AMENDMENT NO. 1 JUNE 2023
TO
IS 17483 (PART 1) : 2020 GEOSYNTHETICS — GEOCELLS — SPECIFICATION
PART 1 LOAD BEARING APPLICATION

Amendment No. 1 to IS 17483 (Part 1) : 2020

FIG. 2 (a) INDIVIDUAL EXPANDED CELL

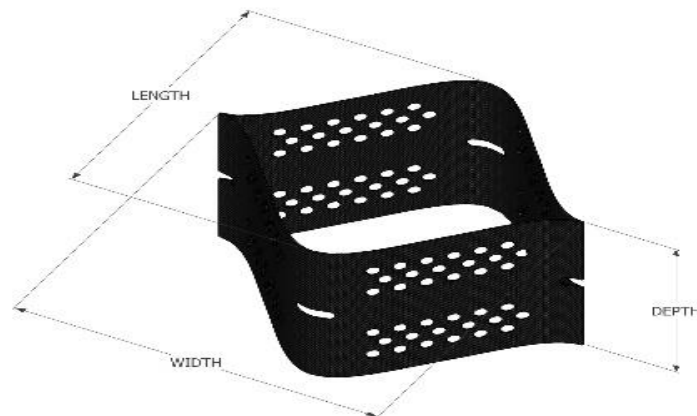
(*Page 2, Fig. 2*) — Substitute the following figures for existing:

‘Geocells used for load bearing application shall have a depth ranging from 125 mm to 200 mm (*see Note*) and final geocell pockets size ranging from 300 mm to 445 mm, when measured by using template as shown in Fig. 2 (c). The expanded individual geocell and geocell panel are shown in Fig. 2 (a) and Fig. 2 (b) respectively for illustration.’

FIG. 5 (a) ULTRASONIC SEAM WELD

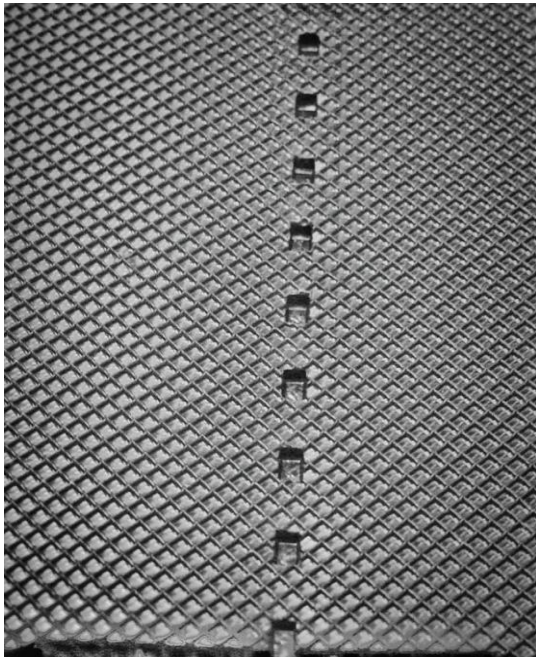
(Page 2, Fig. 5) — Substitute following figures for existing:

The adjoining strips that form the geocell panel shall be welded ultrasonically. The seam weld thus formed shall be uniform [see Fig. 5 (a)]. For uniform seam strength, ultrasonic weld melt pool width shall be 10 mm maximum [see Fig. 5(b)].’
